UNITED STATES PATENT AND TRADEMARK OFFICE

APPLICATION NO.	FILING DATE	FIRST NAMED INVENTOR	ATTORNEY DOCKET NO.	CONFIRMATION NO.				
09/912,070	07/24/2001	Motoyuki Fujimori	U 013566-9	3280				
7590 Ladas & Parry 26 West 61 Street New York, NY 10023		03/12/2007	<table border="1"><tr><td>EXAMINER</td></tr><tr><td>SEVER, ANDREW T</td></tr></table>		EXAMINER	SEVER, ANDREW T		
EXAMINER								
SEVER, ANDREW T								
		<table border="1"><tr><td>ART UNIT</td><td>PAPER NUMBER</td></tr><tr><td>2851</td><td></td></tr></table>	ART UNIT	PAPER NUMBER	2851			
ART UNIT	PAPER NUMBER							
2851								
SHORTENED STATUTORY PERIOD OF RESPONSE		MAIL DATE	DELIVERY MODE					
3 MONTHS		03/12/2007	PAPER

Office Action Summary

DETAILED ACTION

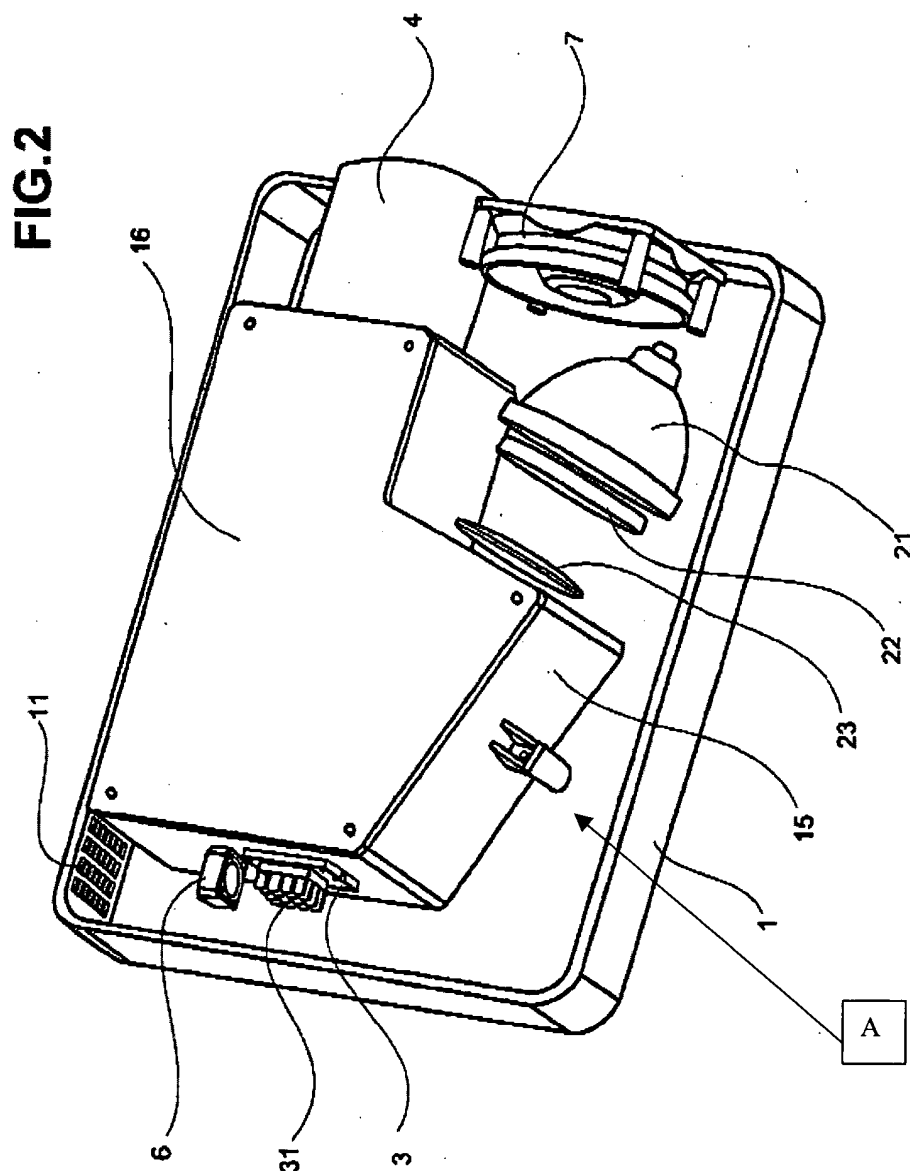
With regards to applicant's claim 9:

The mirrors (36 and 35) as well as the lenses appear to be fixed together by resilient clips (the parts holding them (boxes attached to their sides).

With regards to applicant's claim 15:

The part pointed too below and labeled A by the office is an attachment point that is inherently where a screw is used to fix the inner case to the outer case.
